## Replacing an NE185.01 with an NE355 Fuseboard

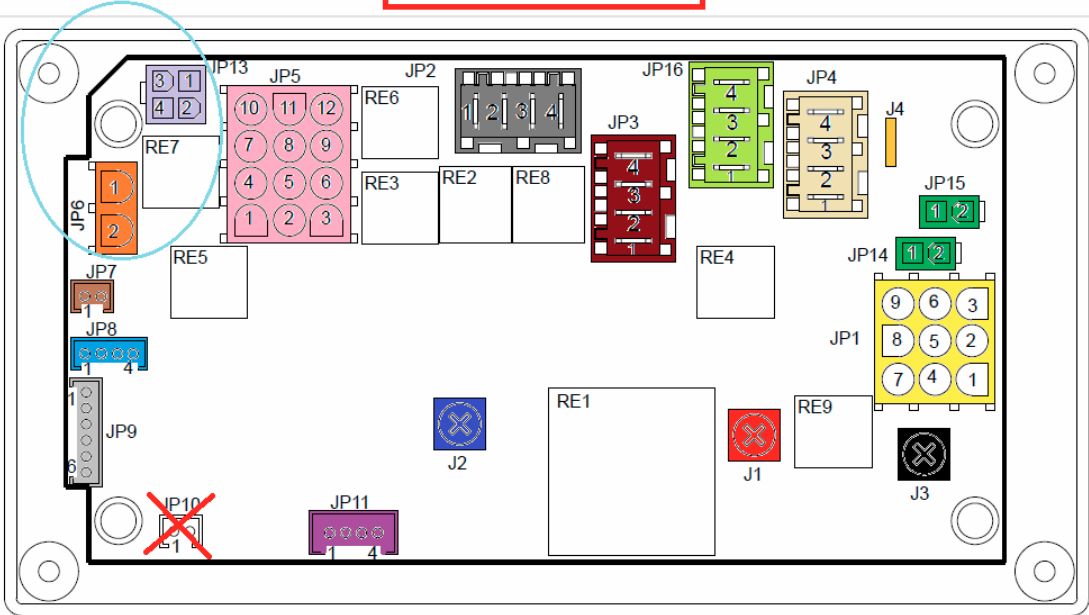
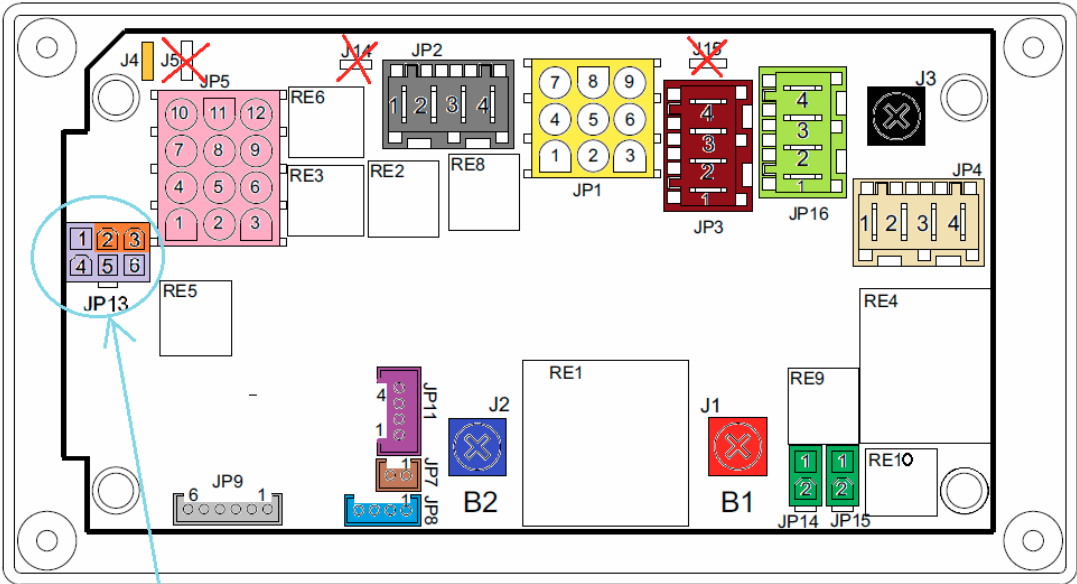
The majority of connections between the two boards are the same. Use the board layout diagrams below to identify the connector designation and simply move the connector from the old board to the new.

The battery connections will be either two RAST5 terminals, or 3 ring/bolt terminals. The NE355 only has ring terminals and so these may need to be fitted.

JP6 and JP13 on the NE185.01 are replaced by one single connector, JP13, on the NE355. A suitable adapter cable is available at additional cost through our website: CAB-NOR-001-NE.

RAST5 style connectors have had their pin numbers reversed on the NE355, however as the NE185.01 and NE355 both have the same style connectors so no rewiring is needed, the pins are just labelled differently.

The affected connections are JP2, JP3, JP4 and JP16.

Adaptor Provided
